Department of Energy
 Richland Operations Office
 P.O. Box 550
 Richland, Washington 99352

INTERPRETATION OF RRL-2 DRILLING RESULTS (SCR-19)

Enclosure to
5/20/83 from
Olson to Wright

BOREHOLE GEOPHYSICAL LOGS
BOREHOLE: RRL-2

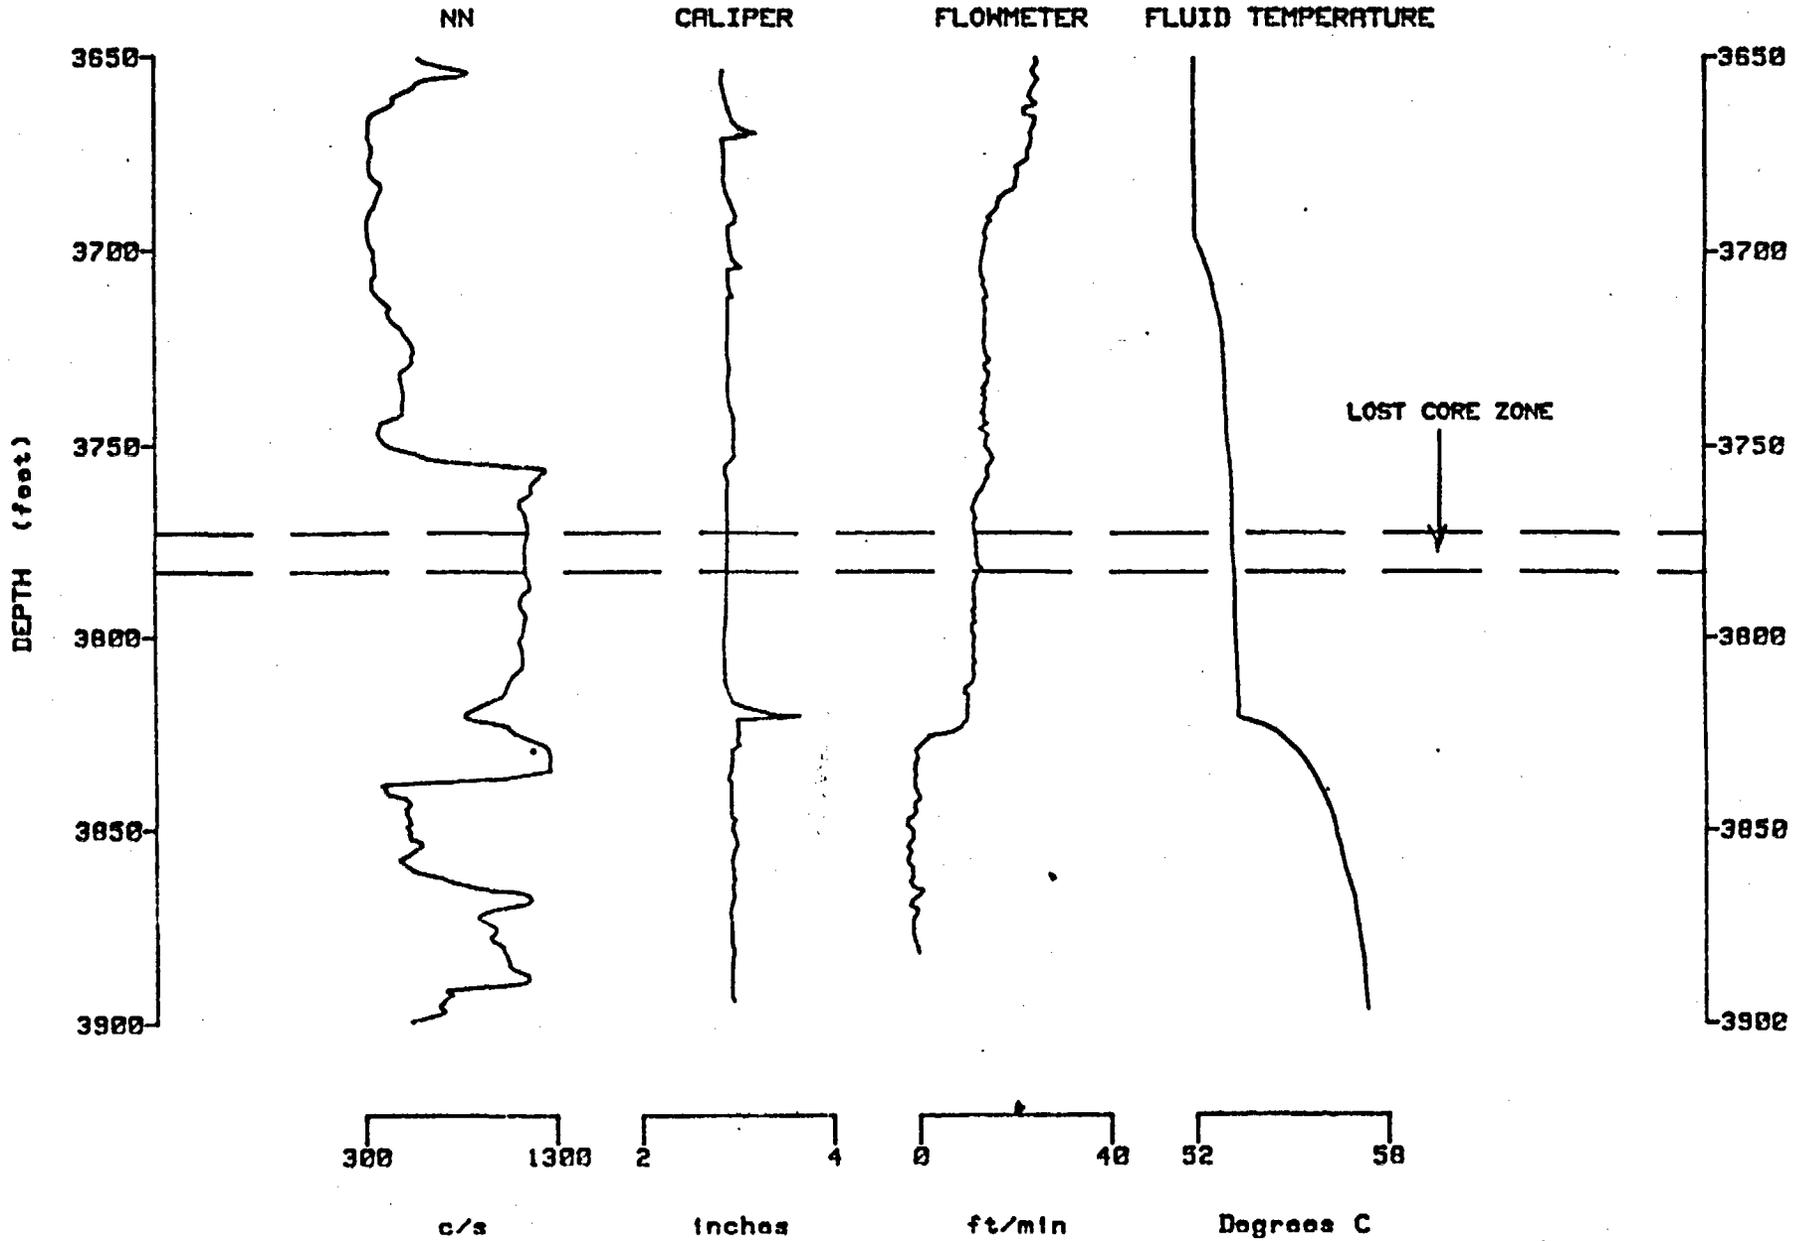
1A. Explain the basis for assuming the 3,773'-3,783' interval of RRL-2 is dense basalt (Reference RHO-BWI-TI-113). What field data and records support this assumption? Is this based solely on hydrological testing and the neutron/neutron log? If so, how much confidence can be placed on this assumption?

The interpretation that the 3,773' to 3,783' interval in borehole RRL-2 is dense basalt is based upon two suites of borehole geophysical logs, a suite of hydrological tests, in situ stress measurements and "Shift Report of Operations".

The borehole geophysical logs performed by Battelle - Pacific Northwest Laboratory (PNL) (attached), across the 3,773' to 3,783' interval, indicate the rock mass to be dense and relatively impermeable. The other suite of borehole geophysical logs conducted by Birdwell indicate identical responses to that of PNL. The neutron log response is typical of a dense interior. The caliper logs do not indicate a washout or out-of-gauge hole. The flow-meter, which was conducted during air lift pumping and fluid temperature logs, do not indicate any fluid passing in or out of the 3,773' to 3,783' interval.

As all data supports the rock in the zone 3,773'-3,783' being dense basalt interior, we have a high degree of confidence that this is the case.
